# Certificate of Appropriateness

<b>Property</b>	3002 W. STATE ST.	<b>Concordia Historic District</b>
<b>Description of work</b>	Rebuild front brick porch, preserving existing porch roof. Install new concrete deck and steps for the porch. Tuckpoint chimney as needed. Tuckpoint house as needed. Replace cracked Bedford Limestone sills with new matching Bedford limestone sills where needed.	
<b>Date issued</b>	3/19/2013	PTS ID 85744 COA, rebuild front brick porch and tuckpoint house as needed

Front

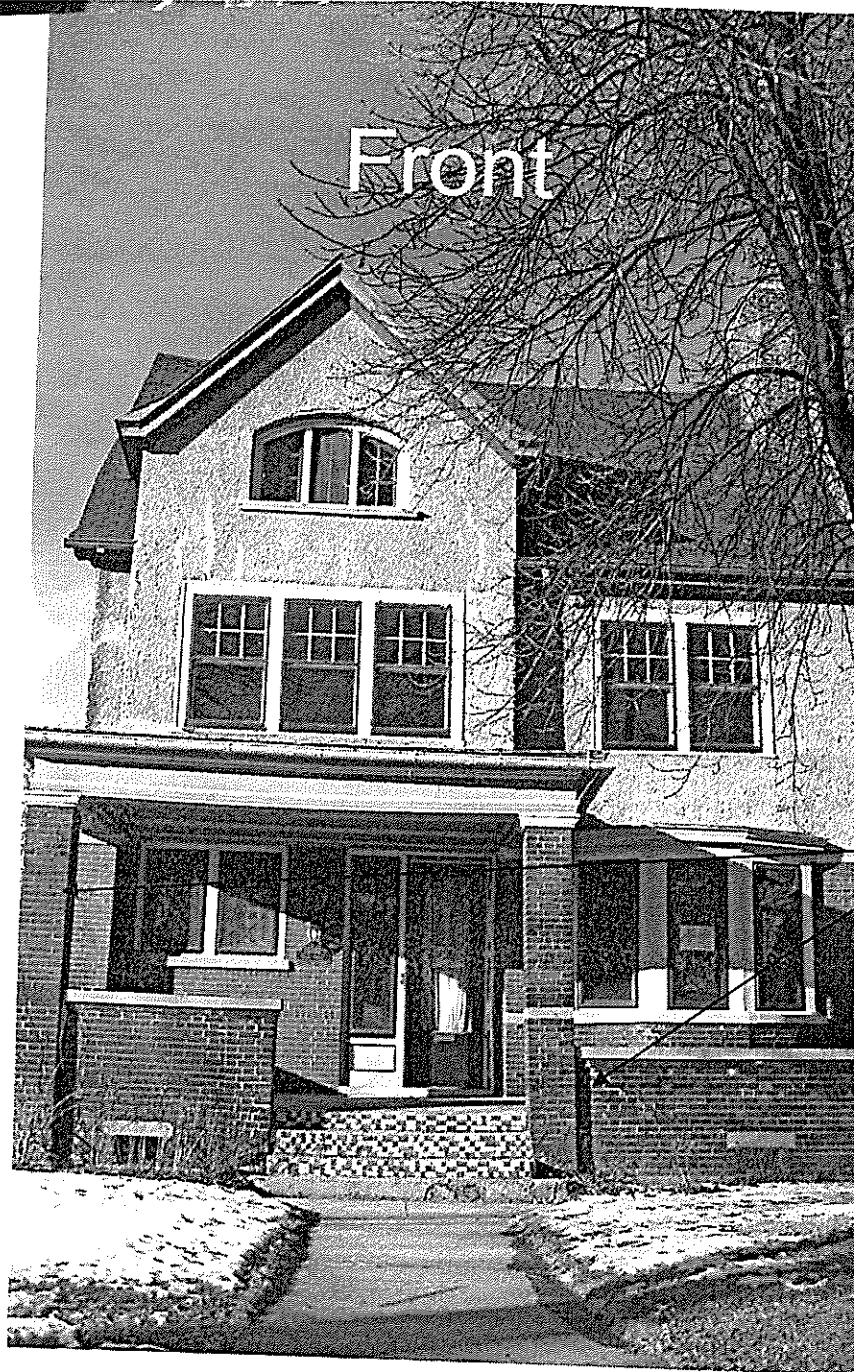
**Preserve and brace existing porch roof in place and remove front brick porch piers, and knee walls, and concrete deck and steps. Rebuild porch using salvaged brick and limestone with mortar to match the original front porch. All mortar must match original in terms of color, texture, hardness joint width and joint finish.**

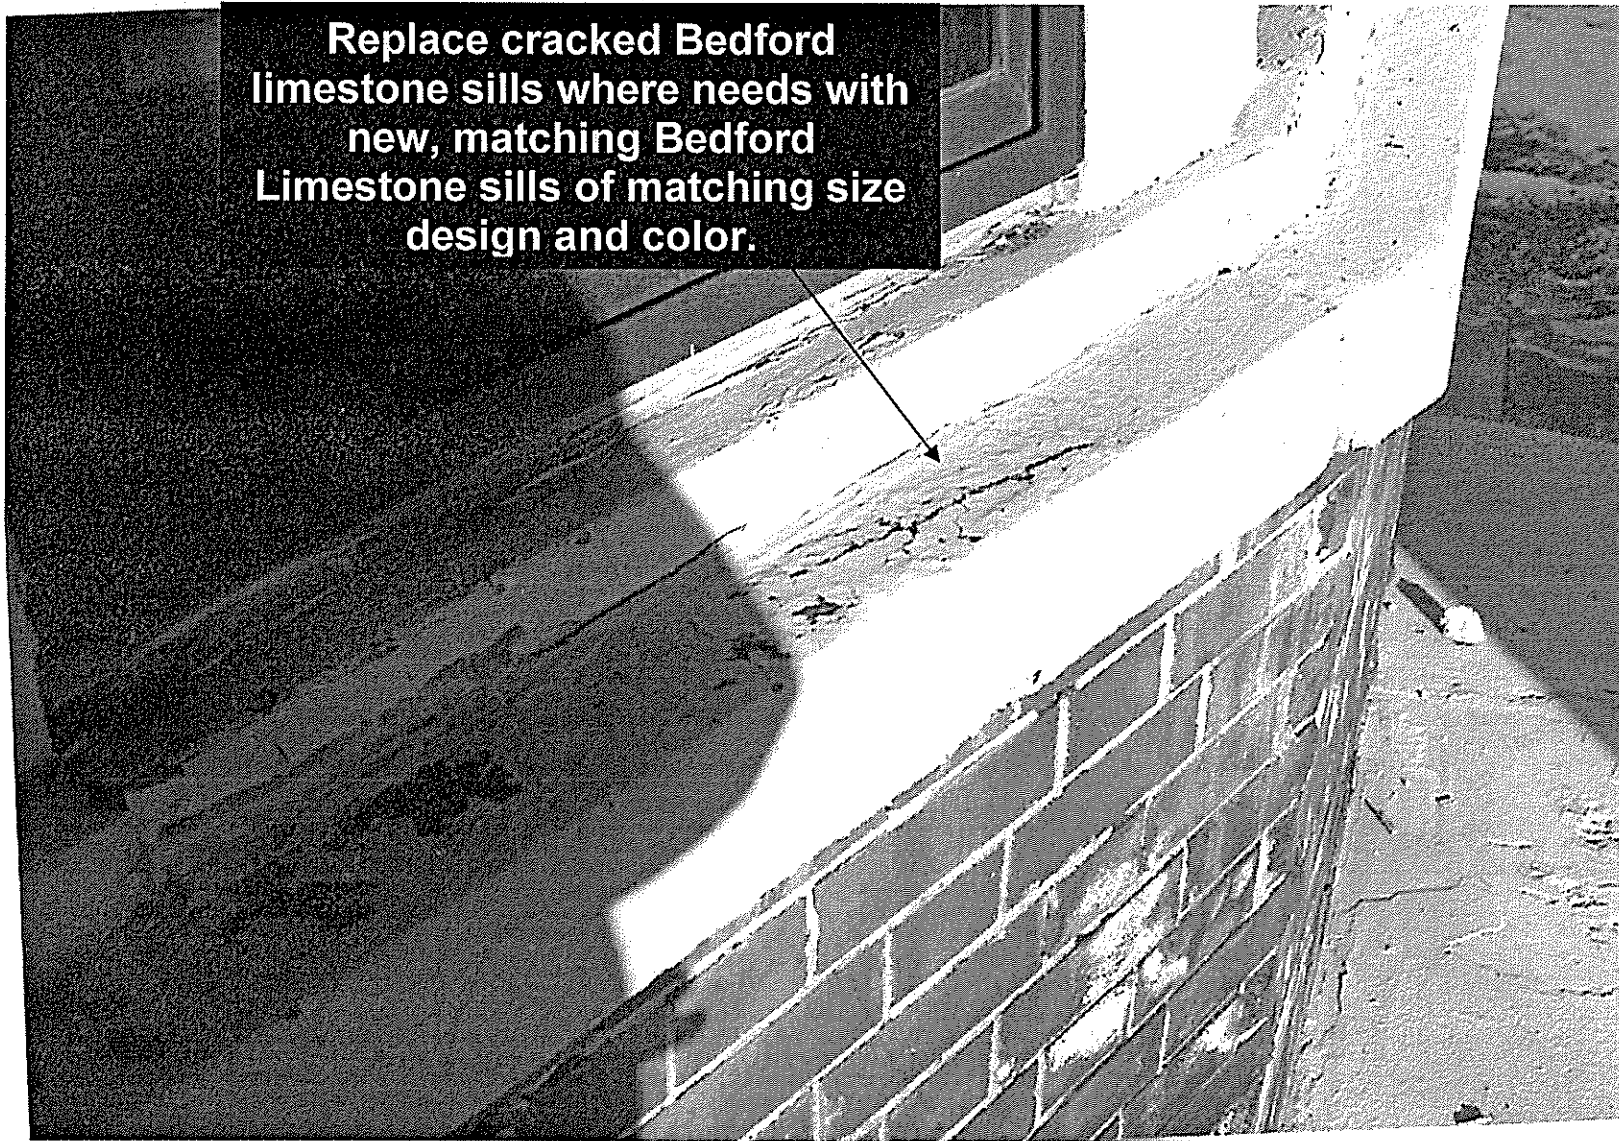
**Replace cracked Bedford limestone sills where needs with new, matching Bedford Limestone sills of matching size design and color.**

**Remove slab and steps and pour new concrete slab and steps in same footprint. Any new brick that may be needed in the rebuild must face the backside of the knee walls where they are not visible from the street.**

Back of house north

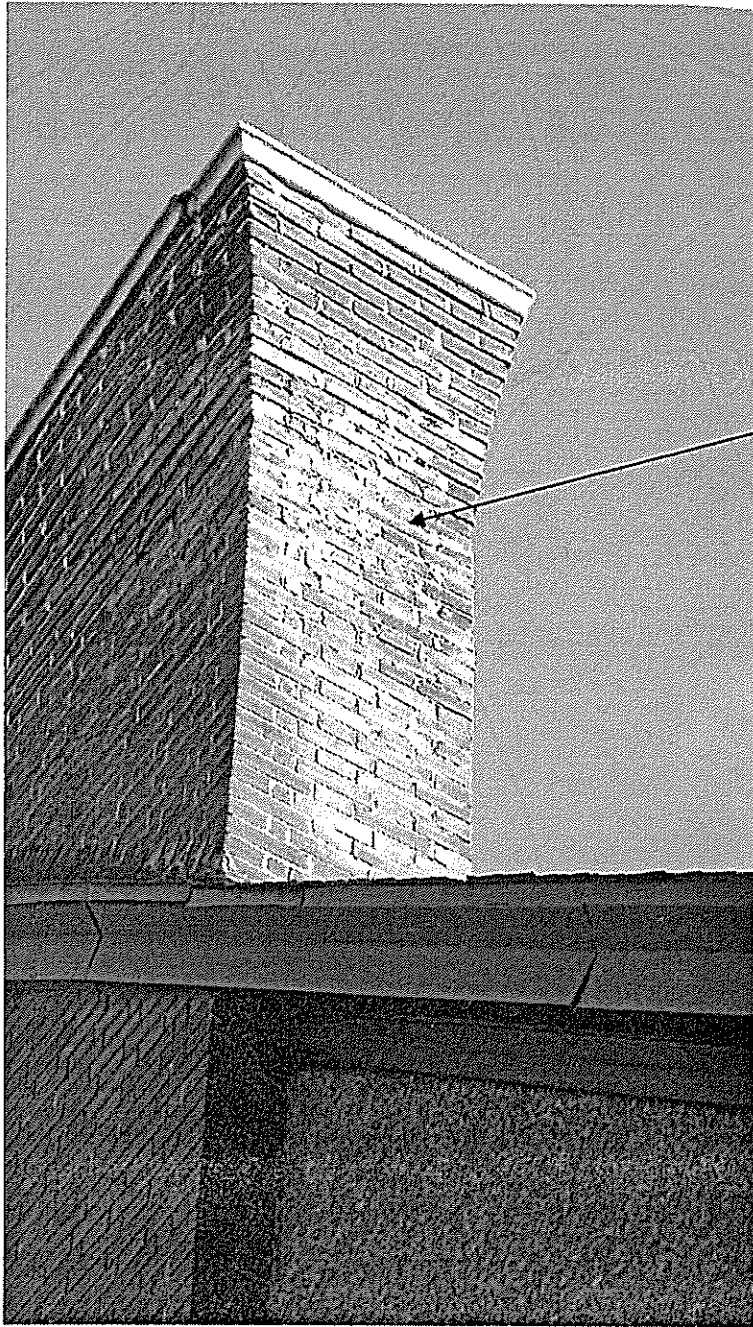
**Tuckpoint brick where needed, but only loose or missing mortar should be replaced. New mortar must match the original in terms of color, texture, hardness, joint width and joint finish.**

***A mortar test panel must be reviewed and approved by HPC staff prior to general commencement of all masonry work.***

**Tuckpoint chimney as  
needed. The design of the  
chimney must not be  
changed.**
